CITY OF SEQUIM
FINDINGS, ANALYSIS, CONCLUSIONS, AND DECISION
PRELIMINARY SHORT SUBDIVISION APPLICATION NO. SHP21-005

DATE: March 9, 2022

APPLICANT: KEITH LARKIN

REPRESENTATIVE: SCOTT HEADRICK, P.E.; ZENOVIC AND ASSOCIATES

Figure 1.

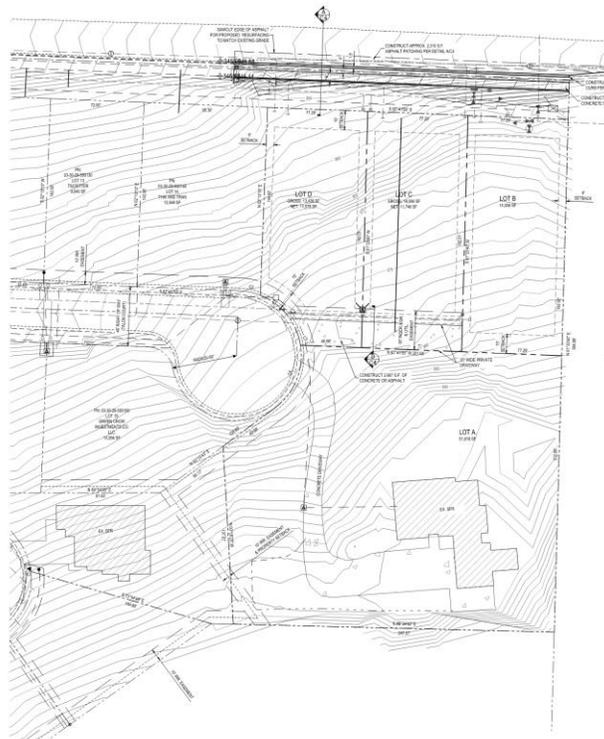
Proposed Development: A proposed short subdivision of approximately 2.14 acres of R 4-8 zoned property into four residential lots. Proposed Lots 1 through 4 would be approximately 1.18, 0.32, 0.27, and 0.31 acres respectively. The proposed lots B, C, and D would be served by common driveway off of Talon Court. **For the purposes of this report proposed Lots A through D will be referenced as Lots 1 through 4 respectively.**
